**HISTORIC LANDMARK COMMISSION
NOVEMBER 18, 2013
NATIONAL REGISTER HISTORIC DISTRICT
NRD-2013-0087
Rainey Street
91 Rainey Street**

Construct an eight-story, mixed use building in place of six contributing houses.

RAINEY STREET
91 RAINEY STREET

PERMIT NO. : SP-2013-0131C

**ARCHITECTURAL
ELEVATIONS**

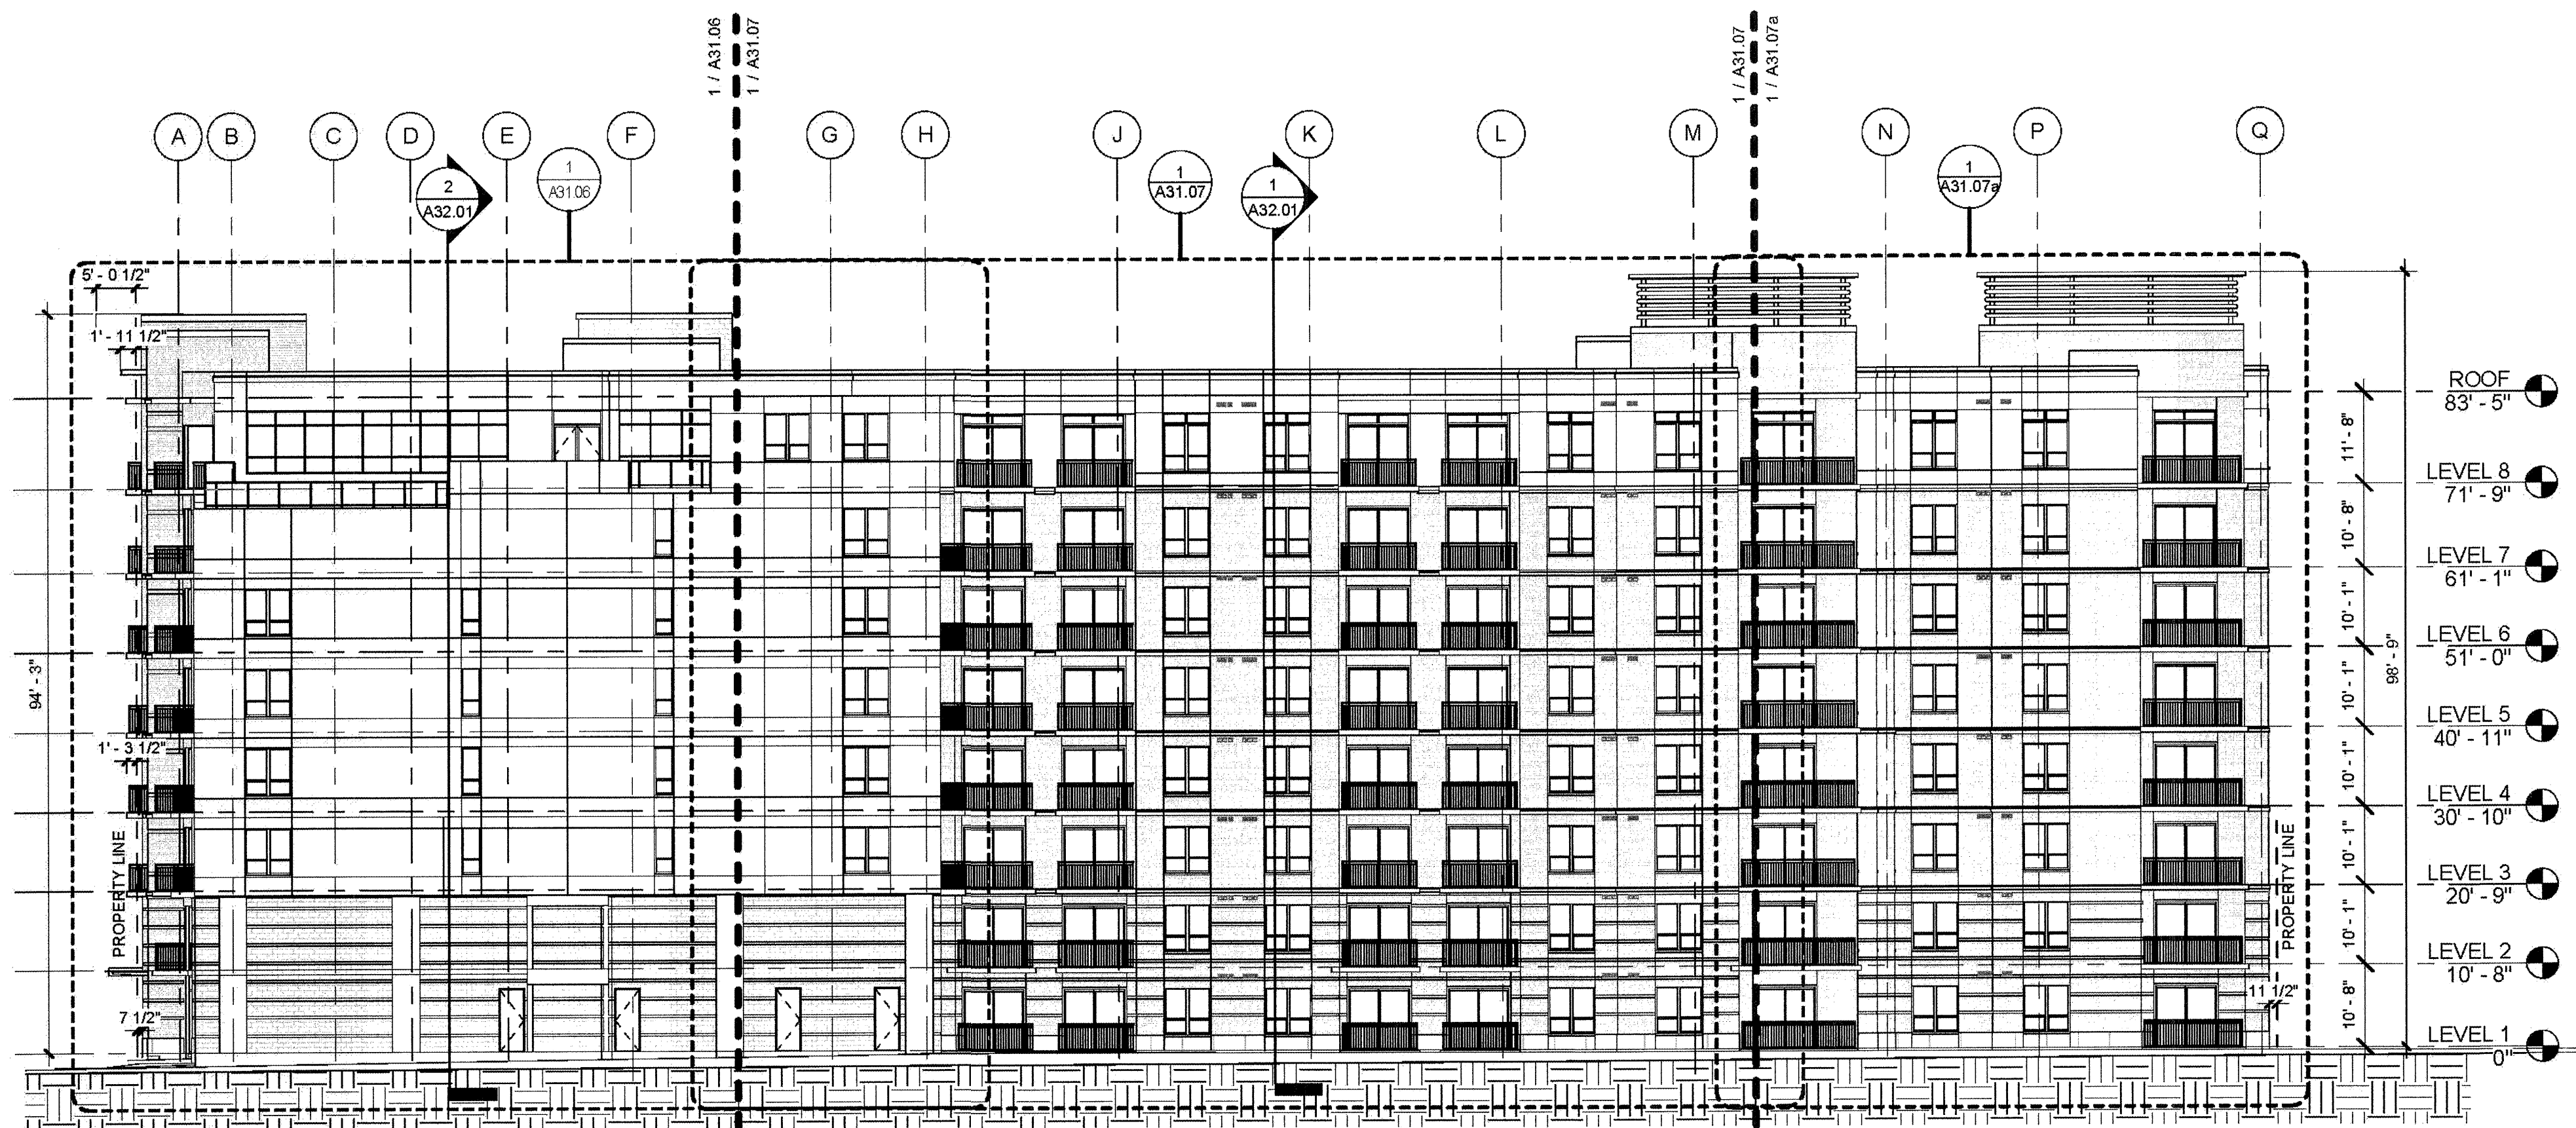
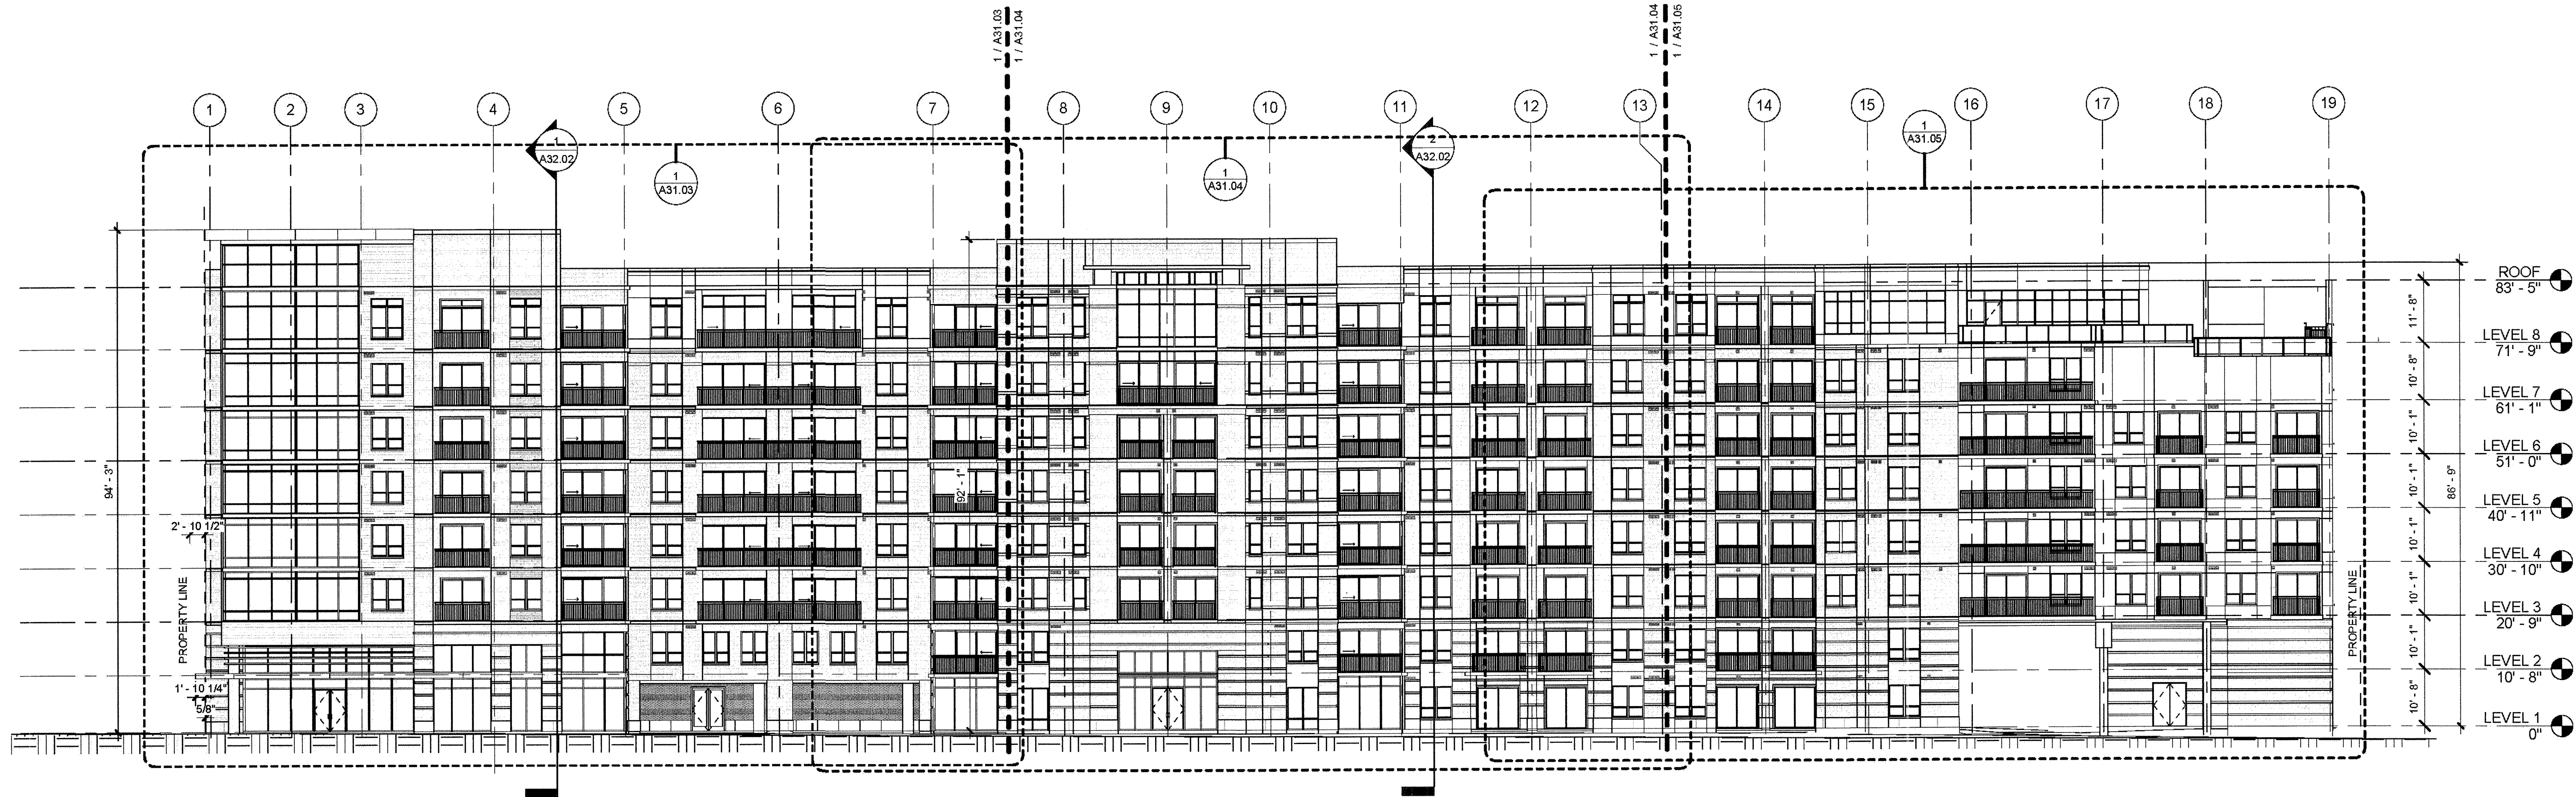
The scale, massing, form and materials of the proposed new building are not compatible with the low-scale, residential character of the Rainey Street National Register Historic District so does not meet the general guidelines.

Release the permit per the proposed design with the request that the applicant consider a design that is more compatible with the character of the District.
